## Final Amendment Report

Veld PV North Solar Energy Facility and  
associated infrastructure near Aggeneys in  
the Northern Cape  
**Veld PV North (Pty) Ltd**

Submission date: 2021/08/31

Figure 3: Proposed amended site layout for Veld PV North (inclusive of the BESS, powerline and infrastructure)

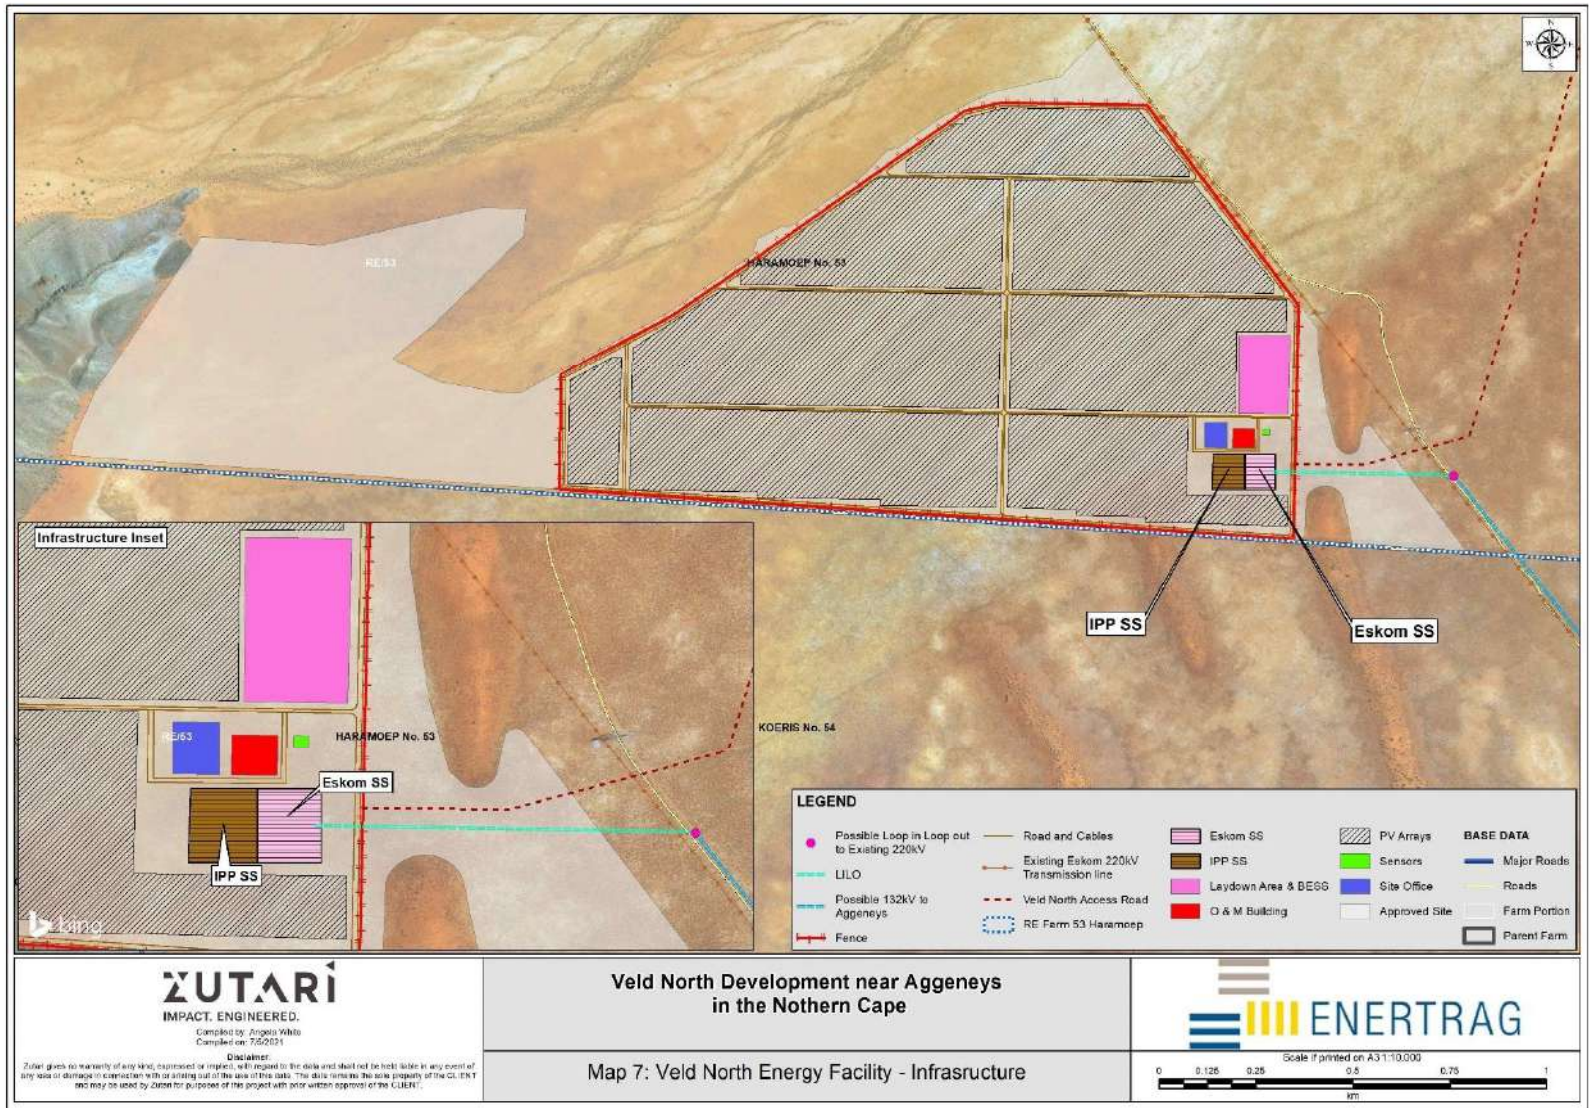
2. The approved final site layout plan (Condition 13), submitted as part of the BAR dated 25 February 2020, is being updated to reflect an updated layout based on the latest optimised technological solution for the facility.
3. The changed the length of the powerline is a correction of a typing error in the EA of 2020 that was only noticed during this amendment process (It appears the lengths were confused between the Veld PV North and Veld PV South applications). The correct length of 25km was applied for and assessed during the Basic Assessment of 2020.
4. The coordinates of the start point of Transmission line have been changed to align with the new position of the proposed substation as a result of the updated layout referred to in point 2 above.
5. The applicant has a new address.

12. A final site layout plan submitted as part of the BAR dated 25 February 2020 is hereby approved.	A final site layout plan submitted as part of the <del>BAR dated 25 February 2020</del> Amendment report dated (TBC) August 2021 is hereby approved.
	Motivation/Reason: <i>The applicant wishes to update the site layout based on the latest technological solution .</i>

Figure 4: Proposed site layout for Veld North Grid connection infrastructure

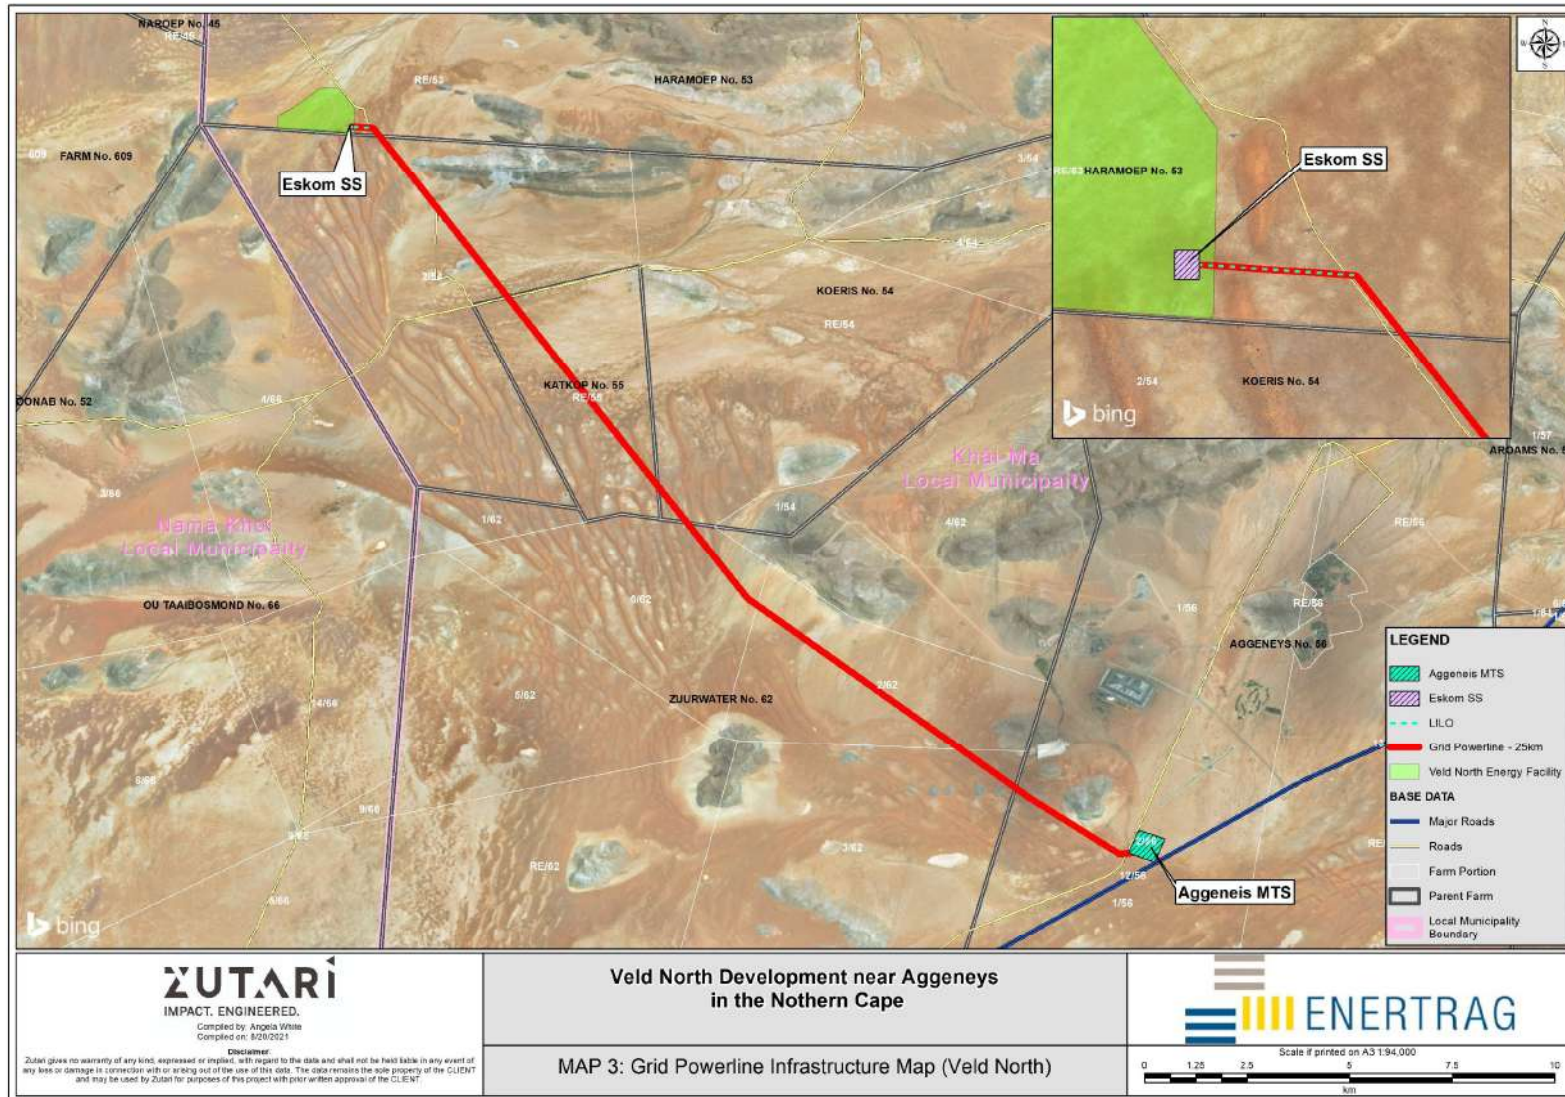
1. The motivation for this Part 2 amendment is that after construction, the grid infrastructure relating to Eskom will be handed over to Eskom. This includes the Eskom side of the onsite substation, powerline (or LILO), and upgrades at the Aggeneis MTS substation. With this physical grid infrastructure handover, all permits relating to this grid infrastructure must also be provided to Eskom. Thus, the current grid infrastructure approved under the existing Environmental Authorisation needs to be split into the IPP portion and the Eskom portion to facilitate this handover.

<b>Page 11 of the EA- Management of activity</b>	
12. A final site layout plan submitted as part of the BAR dated 25 February 2020 is hereby approved.	<p>A final <u>site grid connection</u> layout plan submitted as part of the <del>BAR dated 25 February 2020</del> <u>Amendment Report dated (TBC) August 2021</u> is hereby approved.</p> <p>Motivation/Reason: <i>The layout plan approved is in relation to the Veld North PV Facility and therefore the Grid specific layout plan should be approved.</i></p>
